X:170007.09375 Y:674712.37500 dx:-183.43750 dy:199.00000 Dist 270.64795

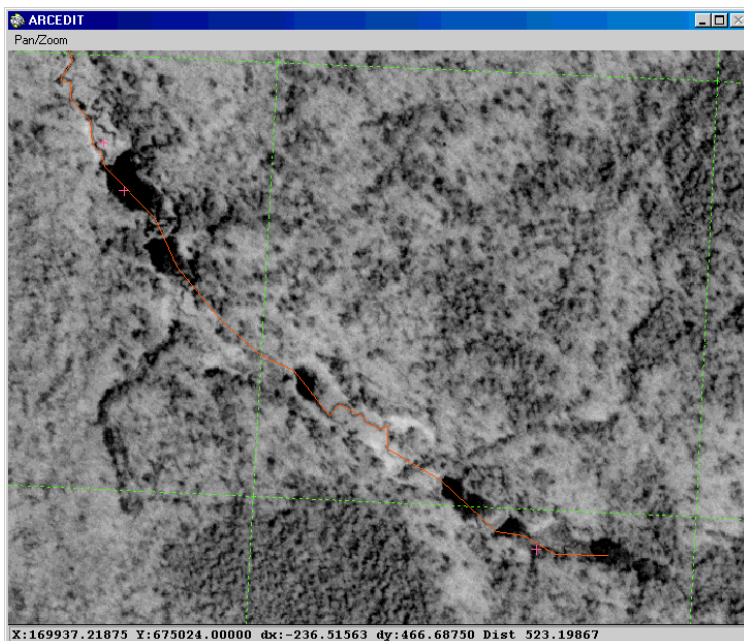
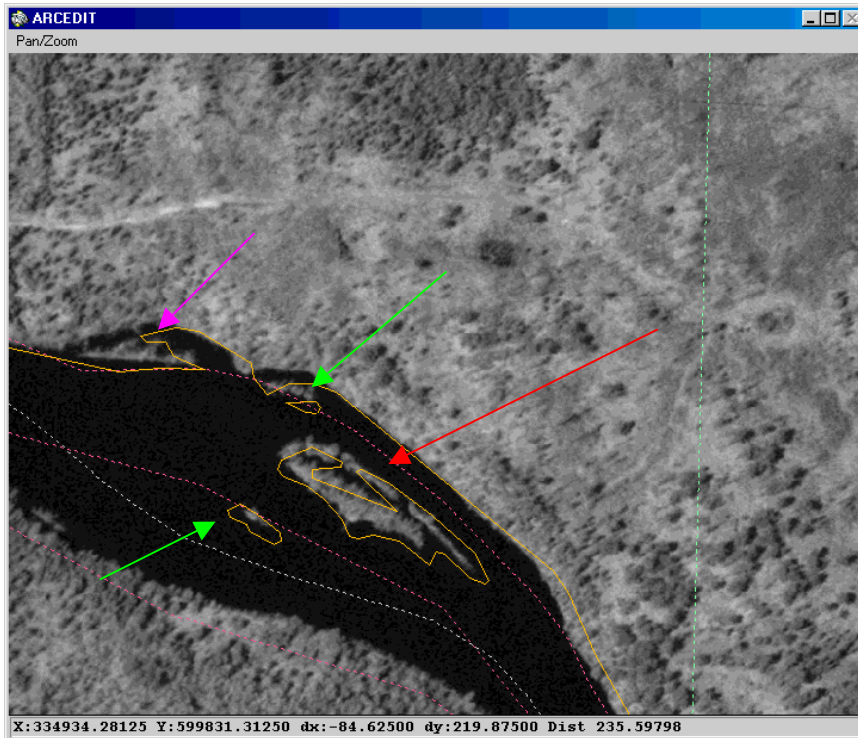
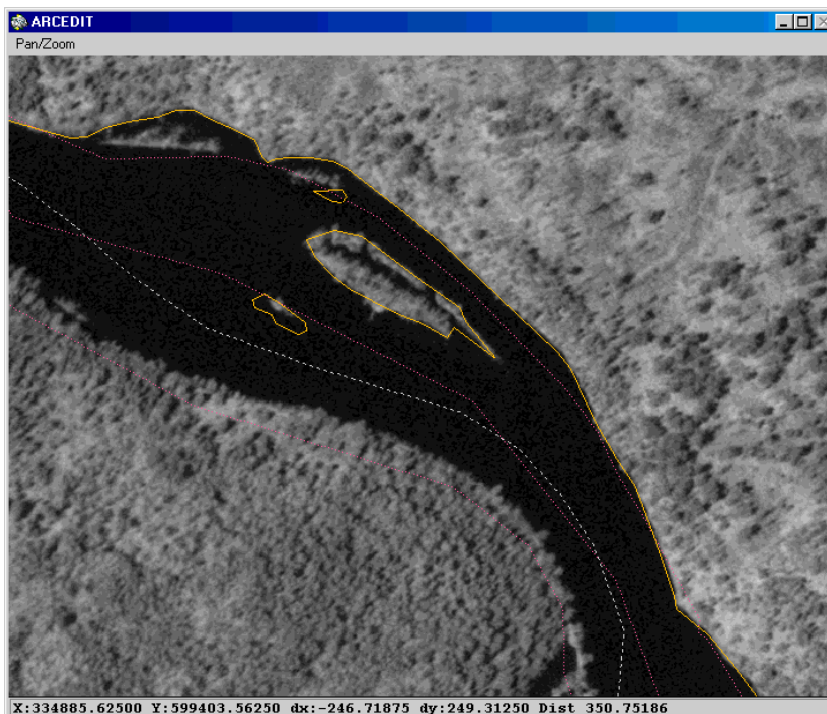
→ Two ponds are less than one acre and are somewhat visible.

→ Two ponds greater than one acre are not visible any longer.

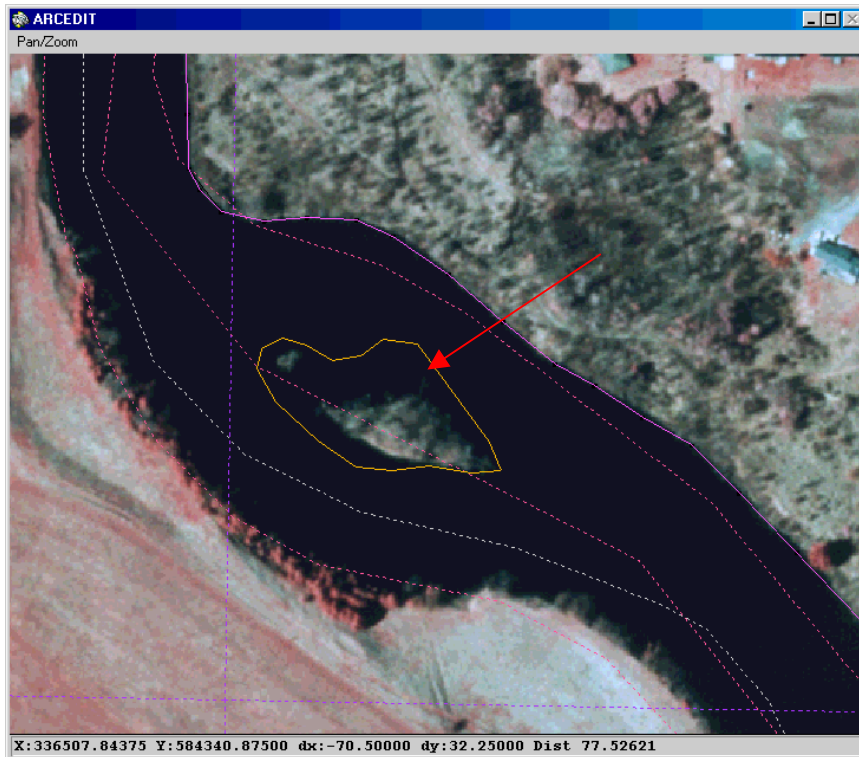
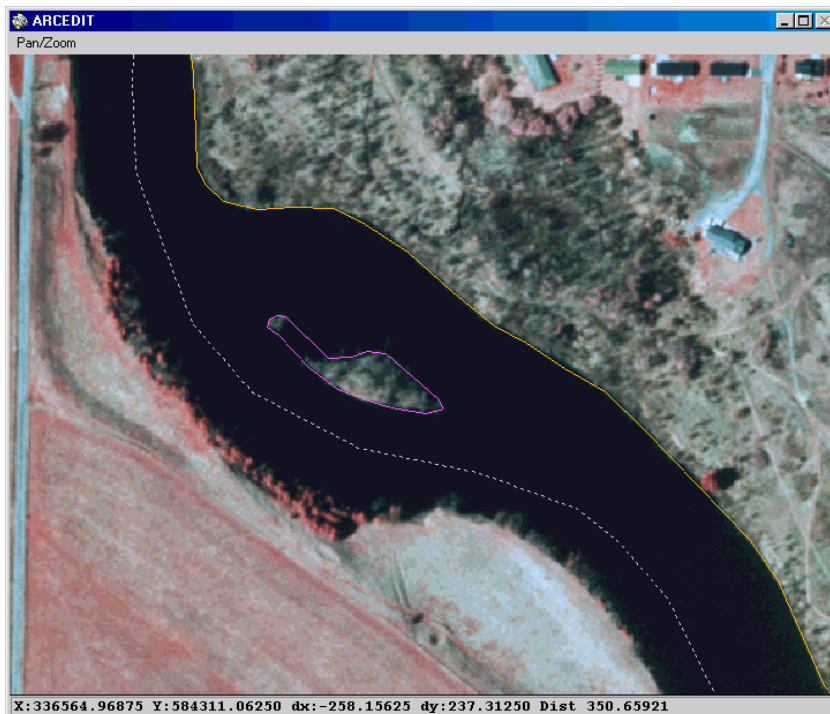
Proposed solution was to remove the small polygons and extend stream headwaters.

X:169937.21875 Y:675024.00000 dx:-236.51563 dy:466.68750 Dist 523.19867

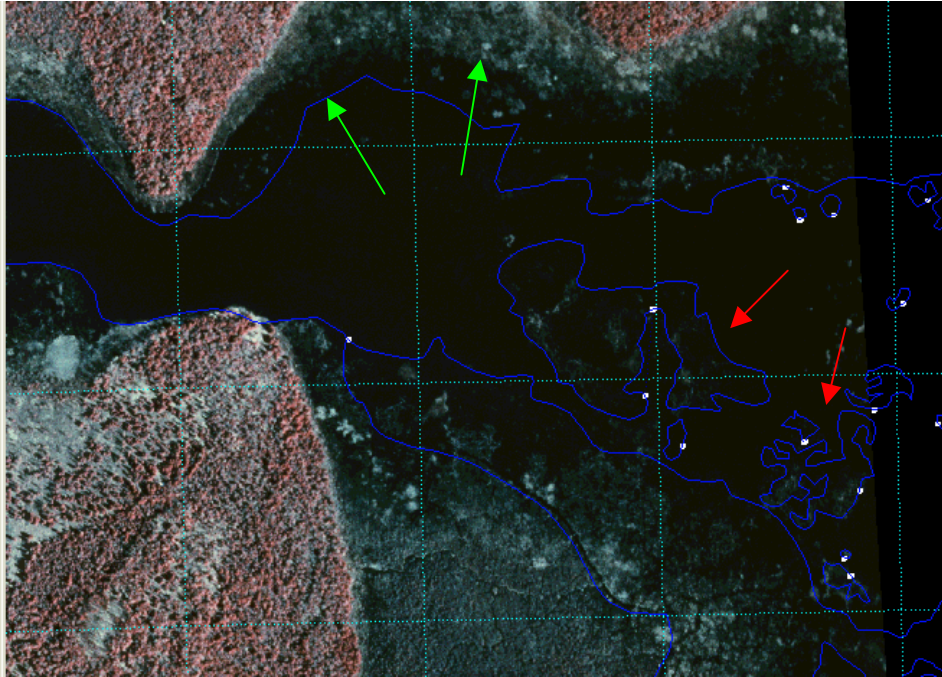
→ Island polygon in coverage is > 1 acre, however, the largest island visible is < 1 acre – proposed solution was to reposition the island polygon around all four islands grouped together.

→ Two other small islands (< 1 acre) in river left untouched.

→ Shoreline repositioned off small island.
